Subject: Duke Energy Corporation  
Catawba Nuclear Station, Unit 2  
Docket Number 50-414  
Response to Request for Additional Information for  
Unit 2 Reactor Coolant System Cold Leg Elbow Tap Flow  
Coefficients

**Attachment 1**  
**Response to NRC RAI Dated December 18, 2002**  
**and Followup Question From Telecon on January 16, 2003**

Figure 8

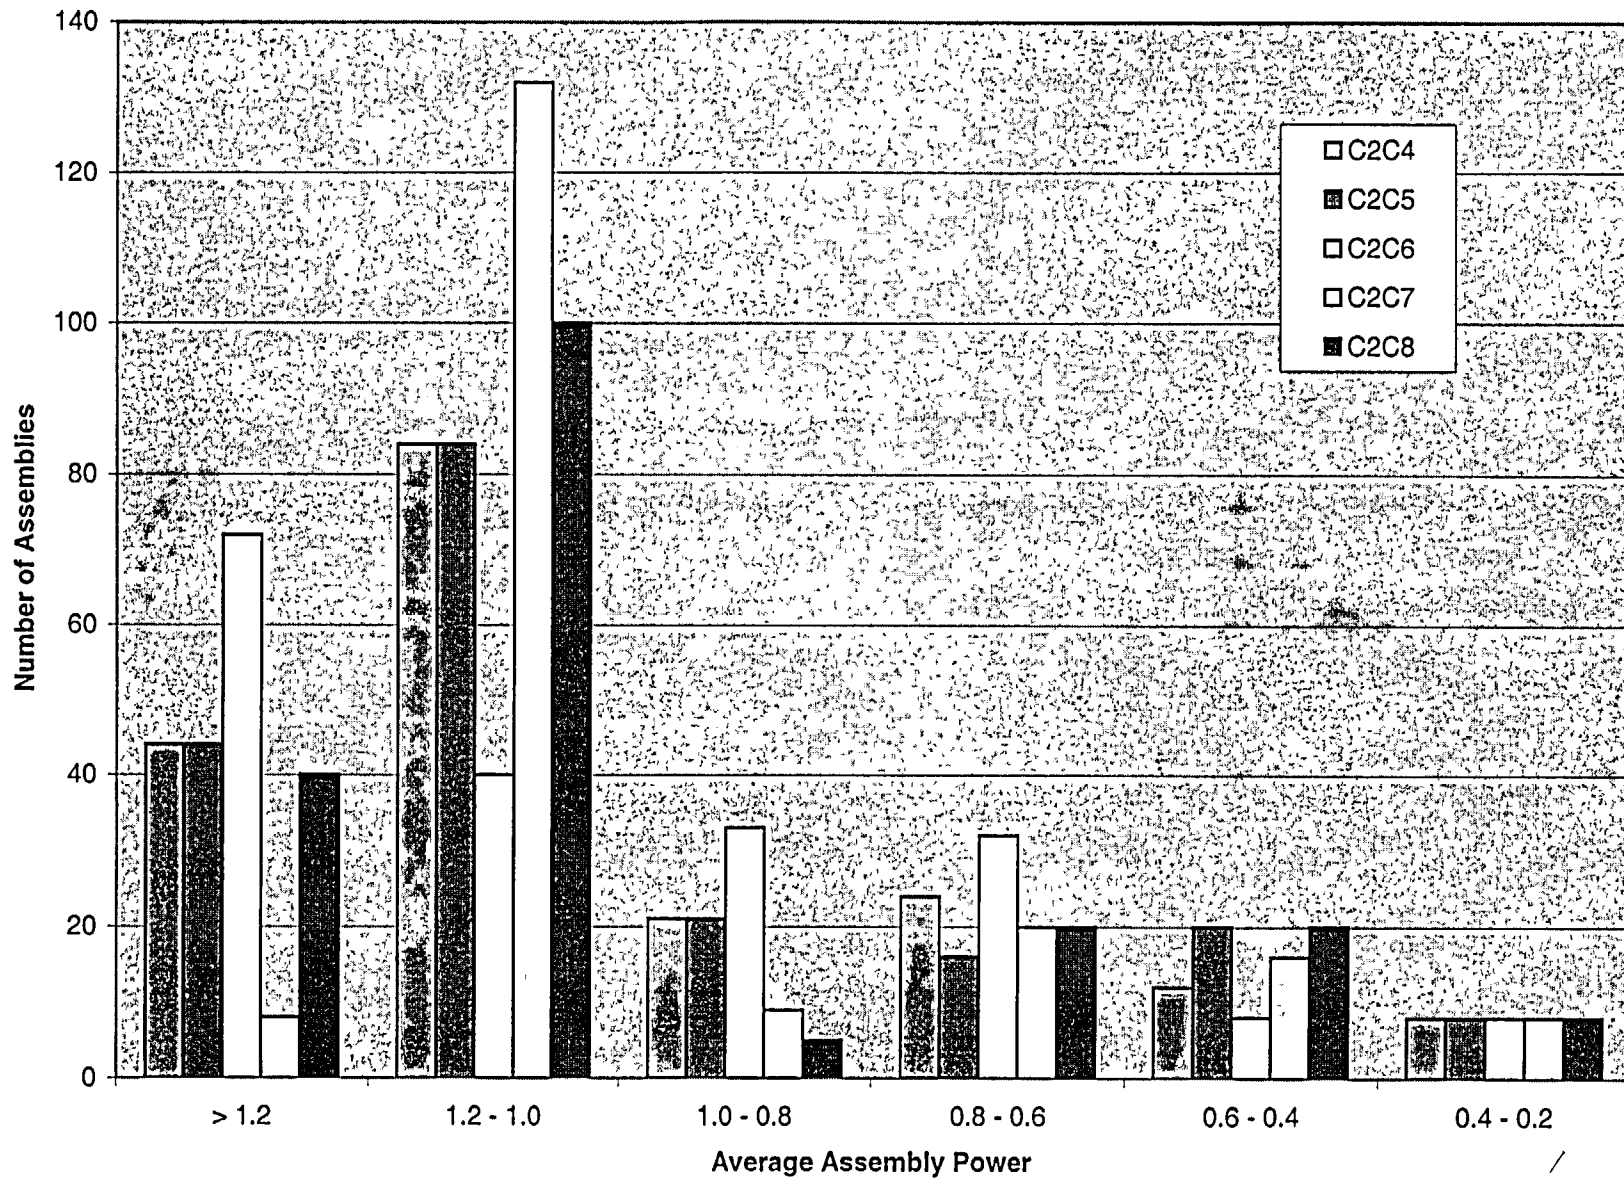
3. The Catawba Unit 2 total flowrate (Refer to Figure 1) as indicated by the elbow tap instrumentation indicates a decrease in flow in the October 1991 and the February 1993 data, followed by an increase in flow. Explain this data trend relative to the flow prediction of the analytical model, which shows no significant flow change, in particular relative to the possible effects of the core power distribution.

The predicted core power distributions for Catawba Unit 2, Cycle 4 through 8, are shown in the attached Figures 6 and 7. These cycles span the time period of the flow decrease of concern. Also shown is a histogram (Figure 8) for these five power distributions showing the number of fuel assemblies as a function of assembly radial peaking factor. The histogram provides an indication of the flatness of the power distribution. It is conceivable that different power distributions could have an impact on the core pressure drop and consequently the loop flowrate. Duke has not considered flow to be sensitive to the core power distribution for the types of core power distributions that characterize McGuire and Catawba reload cores. To quantify this effect

Duke has analyzed Cycles 6 and 7, which are the most different relative to the core power distribution, with the VIPRE-01 code to calculate the core pressure drop. A one-eighth core VIPRE model with one channel per fuel assembly was used. The results of this analysis shows that there was no difference in the core pressure drop to the second decimal point. This was expected since there is no bulk boiling in the core. To confirm that this VIPRE model is capable of calculating a change in core pressure drop due to a change in power distribution, the same model was run with an arbitrary increase in the peaking factor in one fuel assembly (8 fuel assemblies out of 193 in full core). The peaking factor was increased from 1.2 to 1.8 to obtain a channel exit void fraction of 2%. With this unrealistic increase in the power distribution the core pressure drop increased by 0.03 psi. Such a change in core pressure drop will cause no measurable change in loop flow. These results support a conclusion that the core power distribution changes in Catawba Unit 2 during the time period of interest are not associated with the indicated flow trend.
